**ARLINGTON COUNTY, VIRGINIA
OFFICE OF THE PURCHASING AGENT**

INVITATION TO BID NO. 24-CPHD-ITBPW-478

ADDENDUM NO. 1

Arlington County Invitation to Bid No. 24-CPHD-ITBPW-478 for Arlington Neighborhoods Program project along 15th Street N from N Inglewood St to N Kenilworth St is amended as follows:

Sheet C002.1 - Details Revision 1 2024-01-30

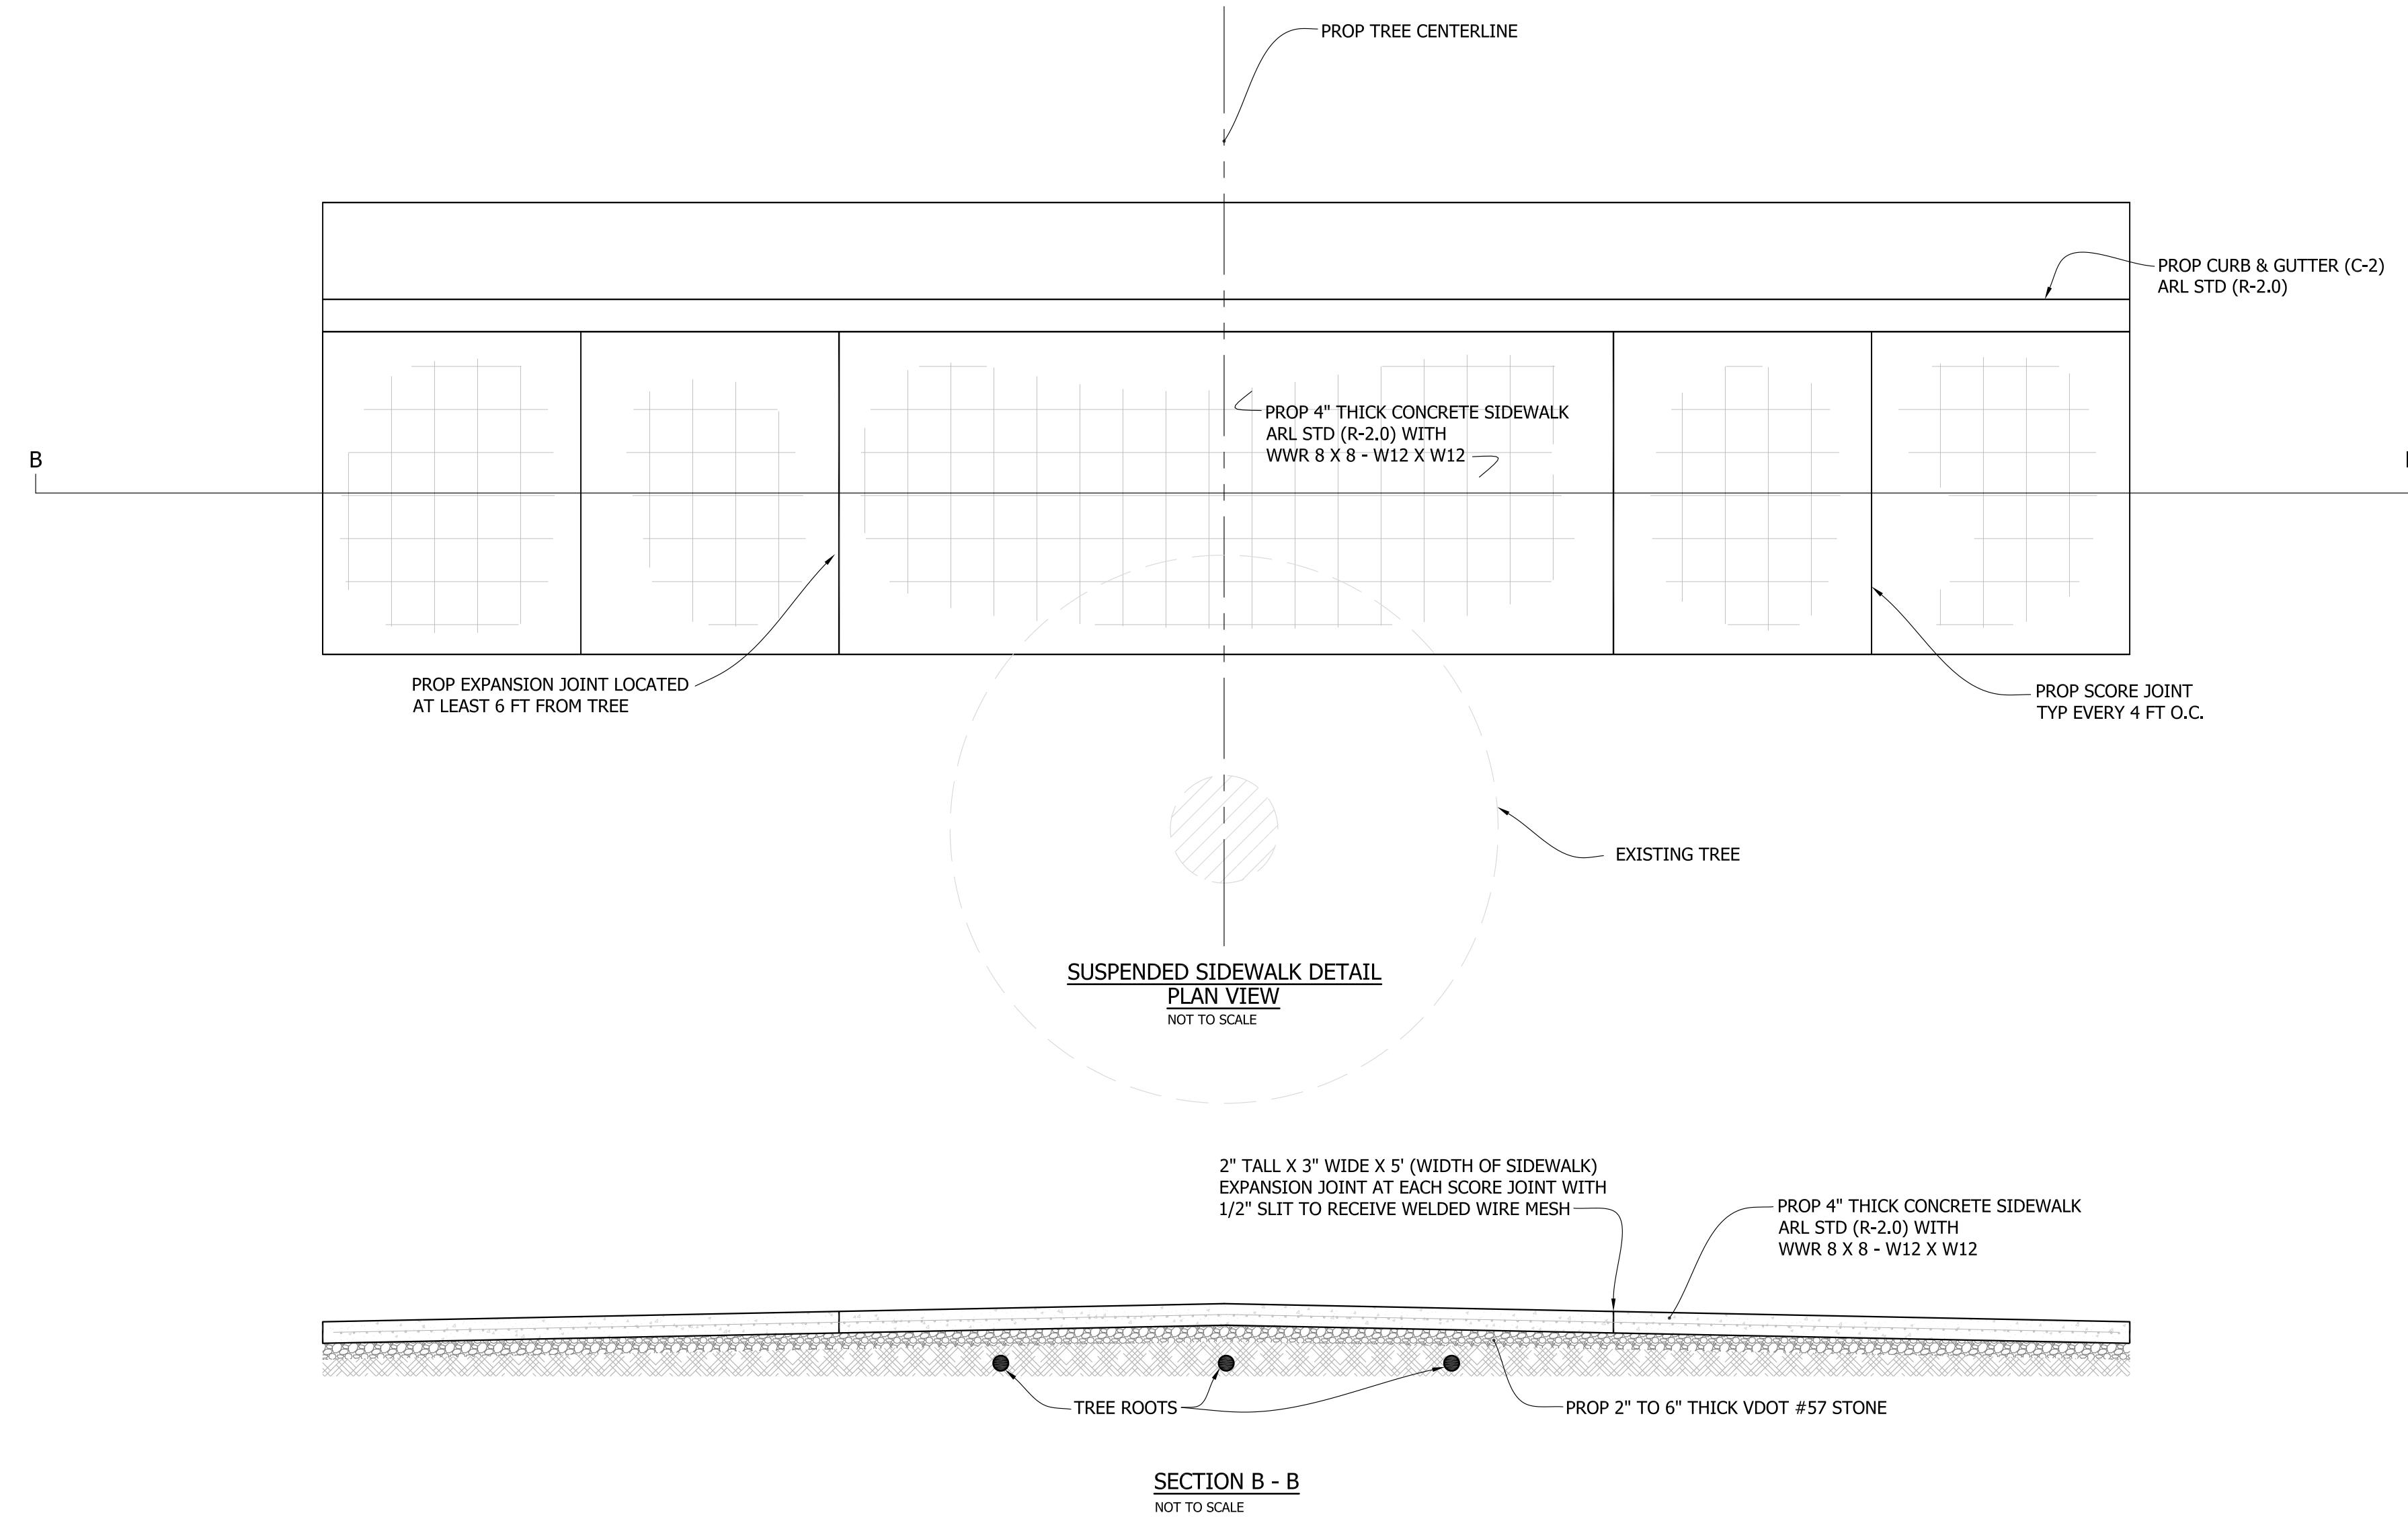
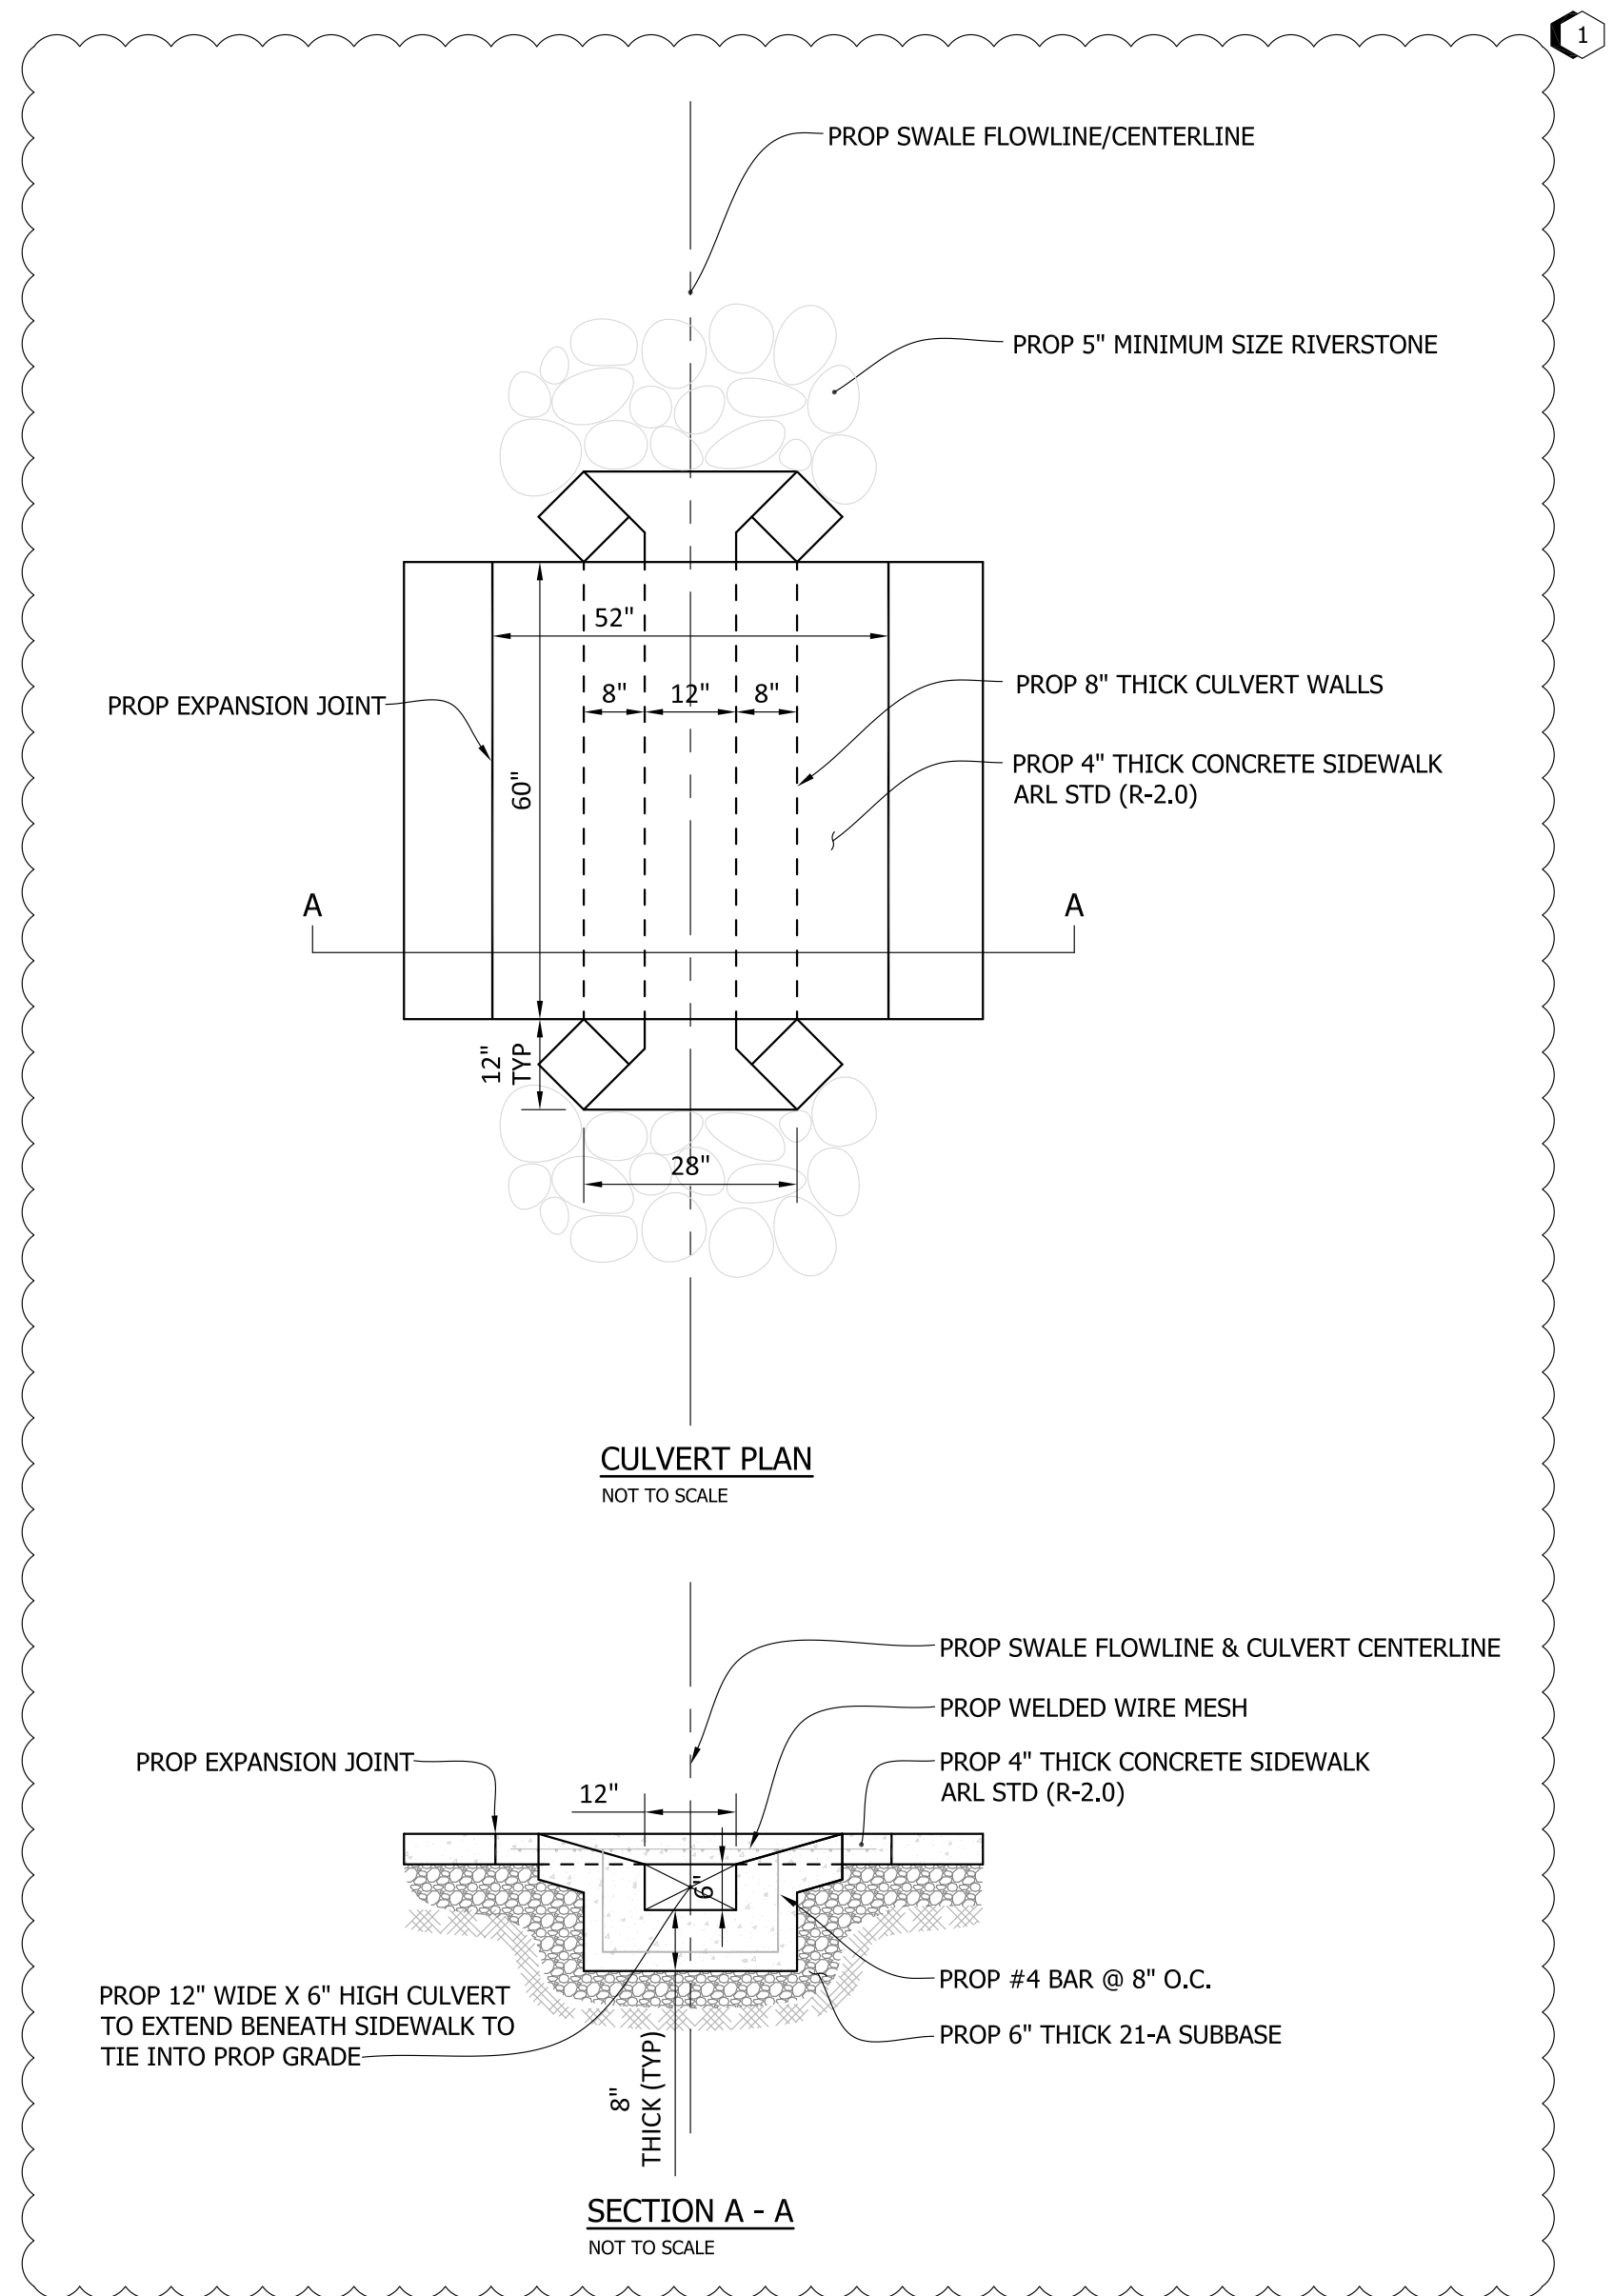
3. Please provide dimensions for the culvert catch basin shown on sheet C002.1

Answer: Proposed dimensions are provided on the revised sheet. Refer to Addendum No. 1 attachment "Sheet C002.1 - Details Revision 1 2024-01-30".

REVISIONS	DATE
1 DIMENSIONS ADDED	01/30/2024
